DATE: June 6, 2019

SUBJECT: ADDENDUM #2 TO THE BIDDING DOCUMENTS FOR:
BID GROUP #6
MASTER FACILITY PLAN IMPLEMENTATION
COMMUNITY HIGH SCHOOL DISTRICT 99
1436 NORFOLK STREET
DOWNERS GROVE, IL 60516

This addendum forms a part of the Bidding Contract Documents, dated May 10, 2019. Bidders must acknowledge receipt of this Addendum in the space provided on the Bid Form.

C4.01

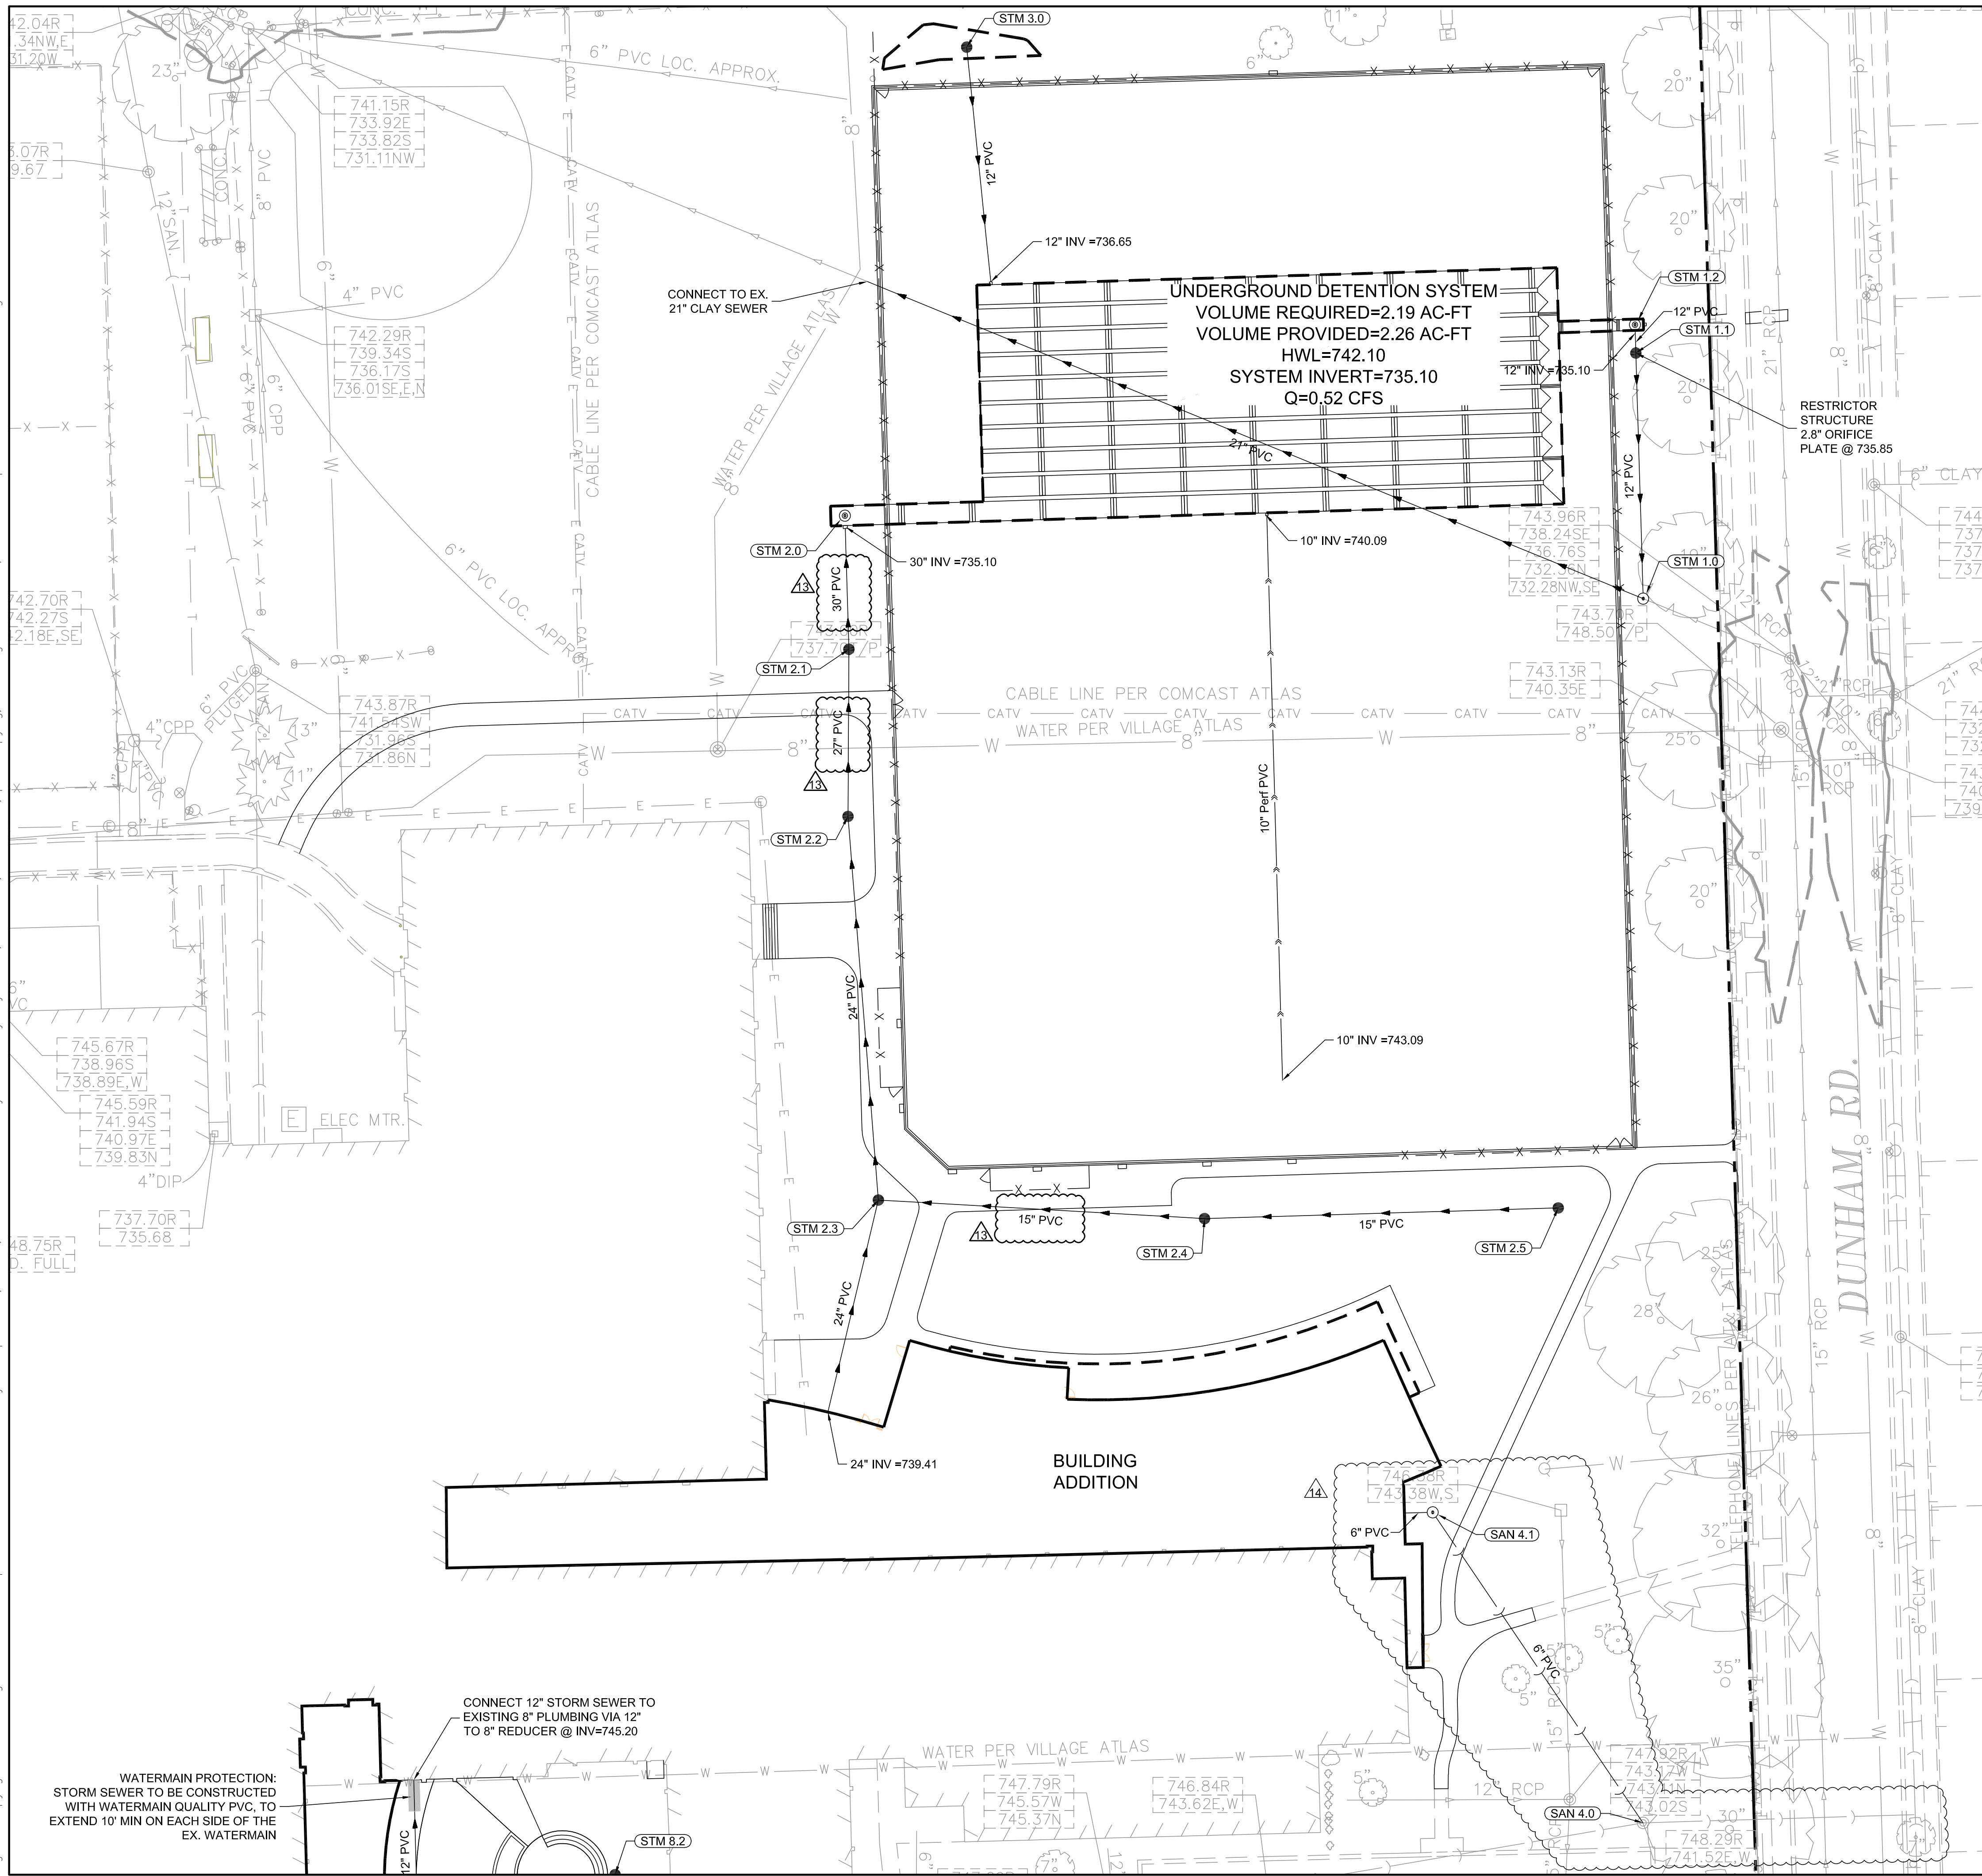
1. Sheet C4.01 UTILITY PLAN - SOUTH (**Full size sheet reissued**): Sanitary line added as indicated.
2. Sheet C4.05 UTILITY PROFILES PLAN - SOUTH (**Full size sheet issued**): New sheet issued for added sanitary line.

20 TYPICAL EXPANSION JOINT DETAIL
N.T.S.

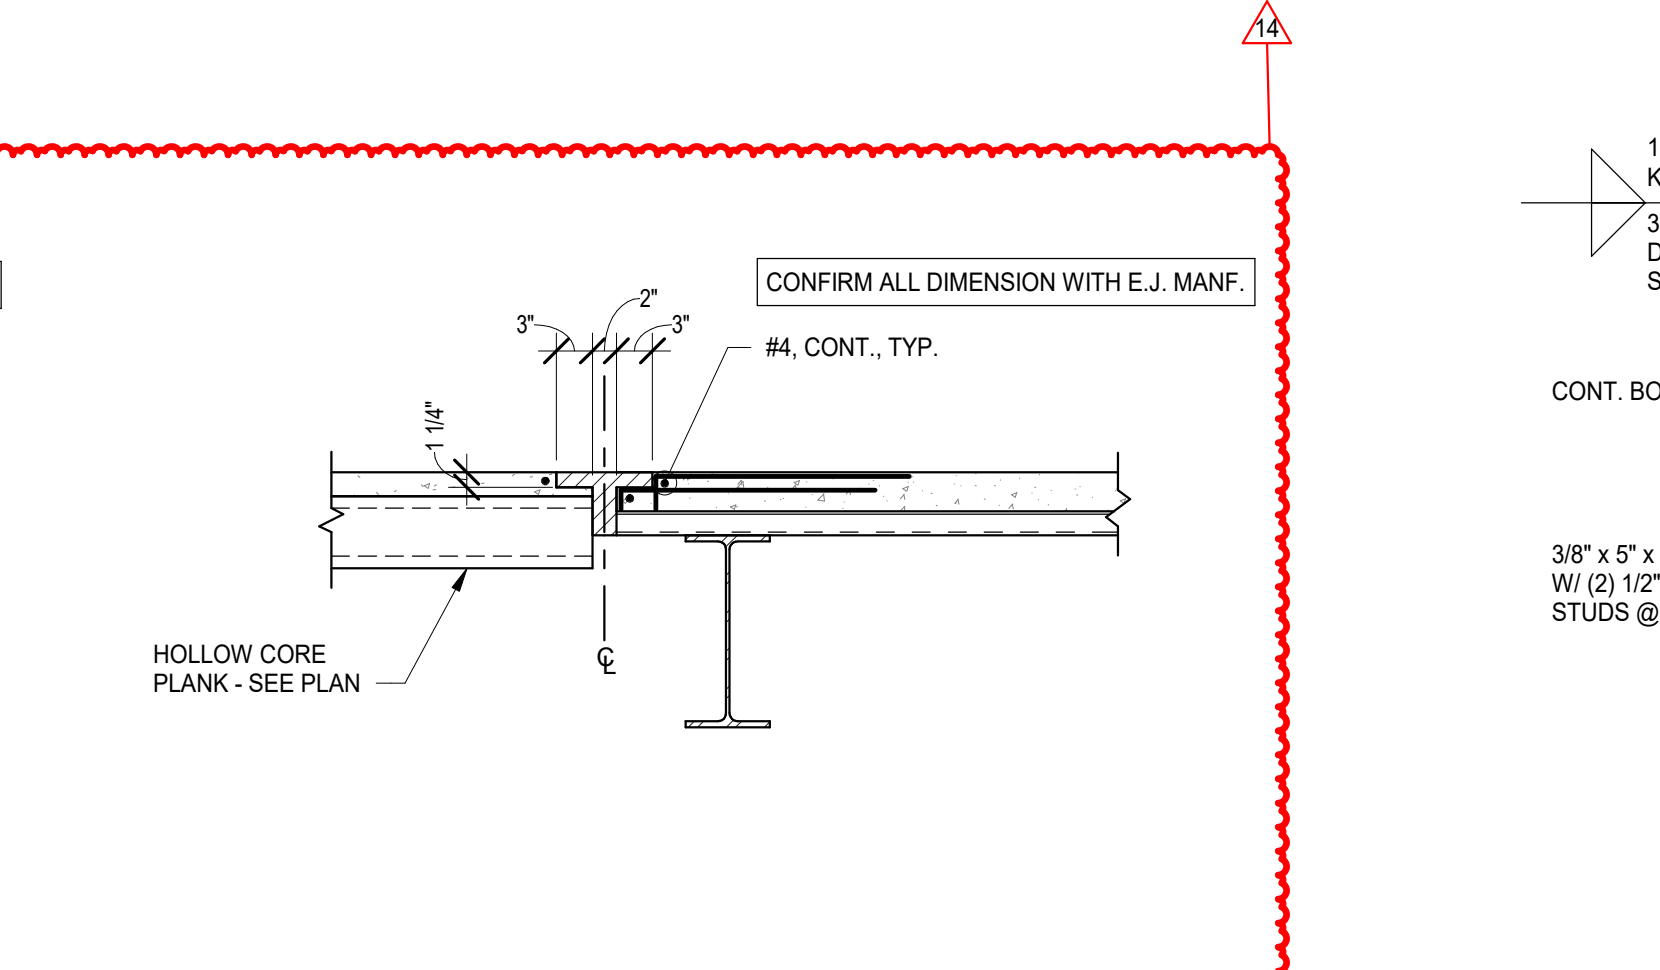
- a. Typical expansion joint details added.
5. Sheet S1.3B TYPICAL SECTIONS AND DETAILS (**Full size sheet reissued**):
 - a. Typical expansion joint detail added.

17 TYPICAL EXPANSION JOINT DETAIL
N.T.S.

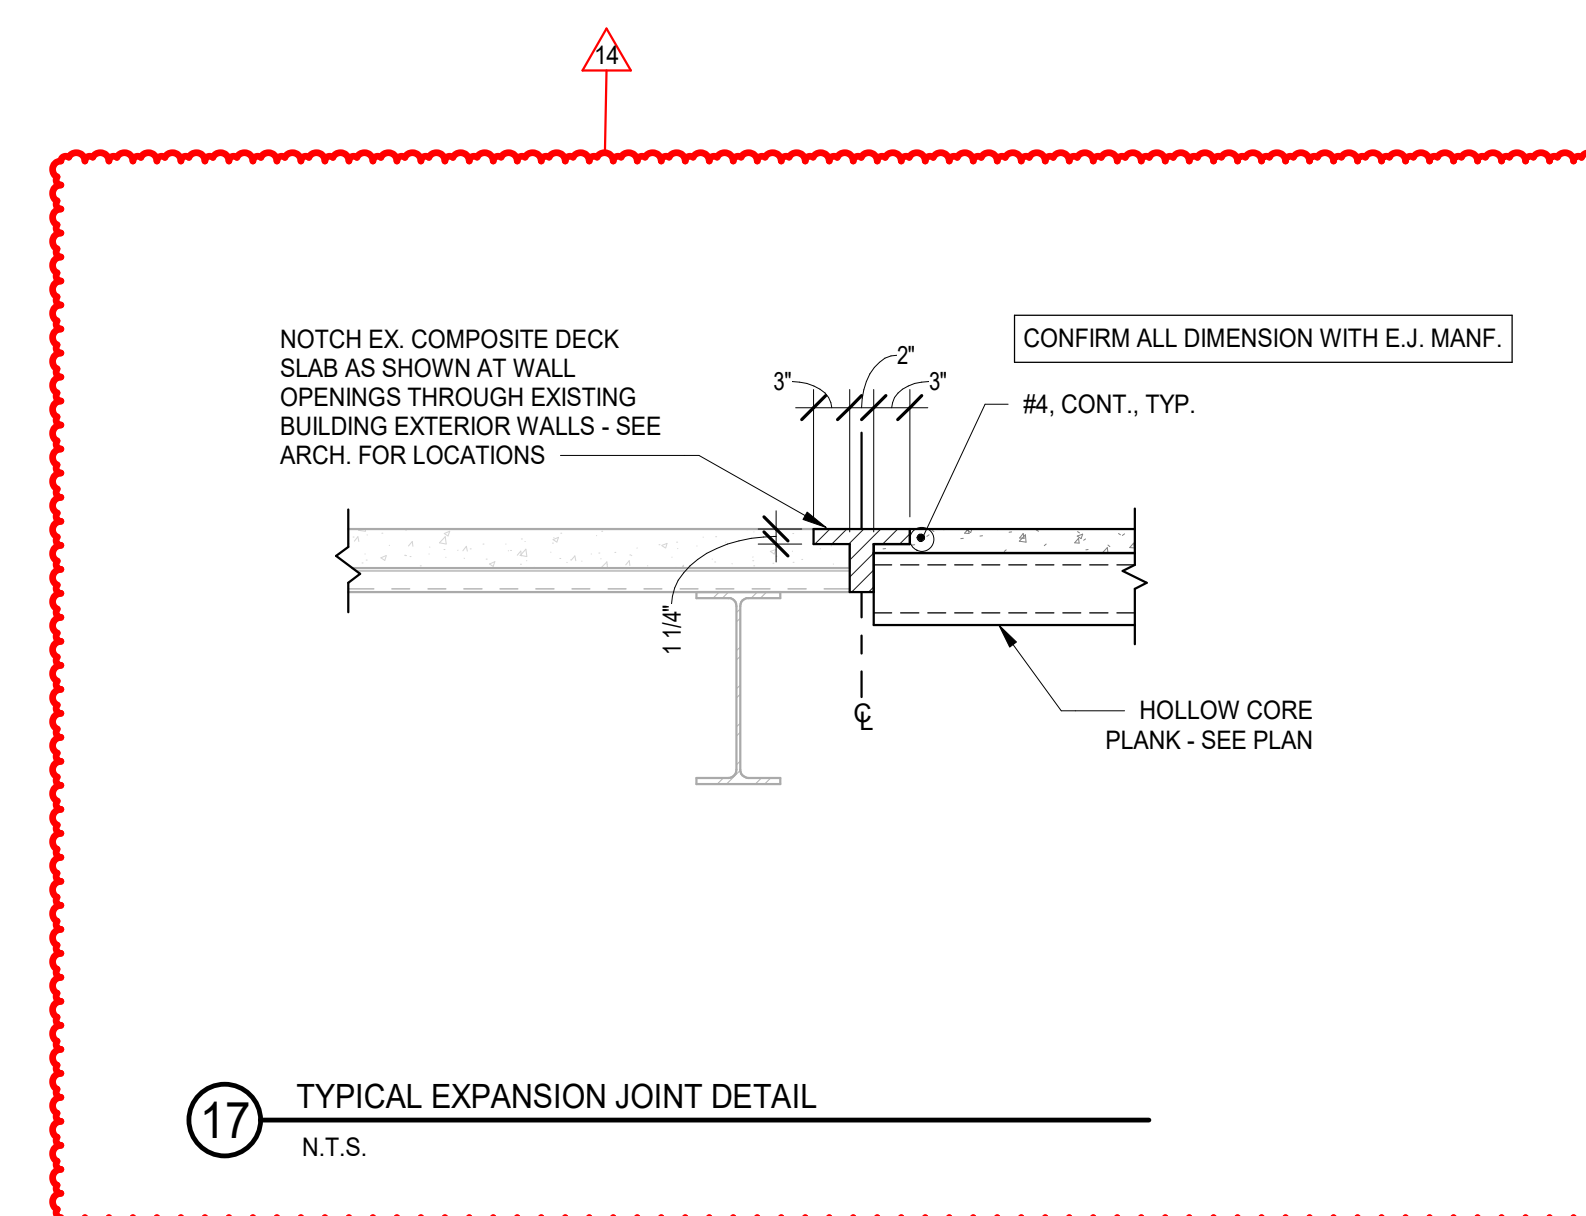
NOTE: This trade contractor is responsible for detail 17/S1.3B including notching the existing composite deck slab for installation of expansion joint.
